From: Peter MULCAHY <WBBSARA@dsdilgp.qld.gov.au >
Sent: Monday, 29 April 2024 12:21 PM
To:
Cc: Lyn McLeod; North Burnett Regional Council
Subject: Proposed MCU application at 16191 Burnett Highway, Gayndah (Council Reference: DA240013)

Proposed MCU application at 16191 Burnett Highway, Gayndah (Council Reference: DA240013)

Proposal Plan (2)

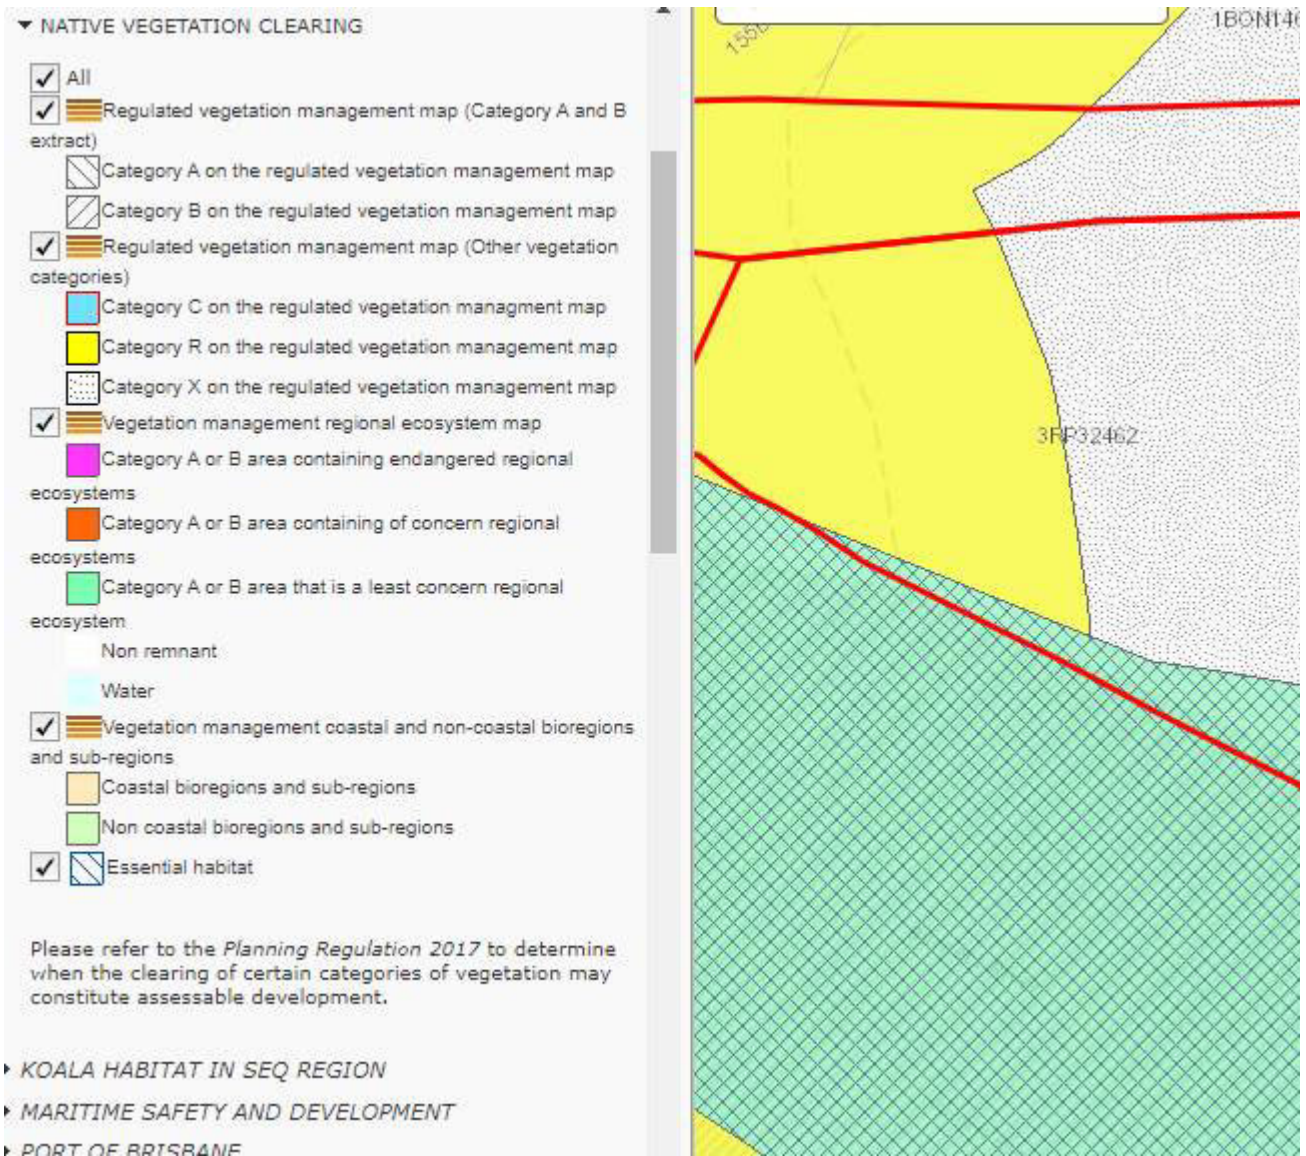
The proposal plans received are illegible and not drawn to scale. SARA request that the applicant provides proposal plans which are prepared in accordance with the [DA forms guide: Relevant plans](#).

It is strongly recommended that you prepare better quality proposal plans and submit to SARA and North Burnett Regional Council (NBRC). The current plans cannot be used by SARA for assessment purposes.

The proposal plans do not provide sufficient detail to determine whether the ten (10) self-sufficient cabins require:

- the clearing of Category B 'least concern' remnant vegetation
- a firebreak (additional exempt clearing for infrastructure based on the location of the cabins)
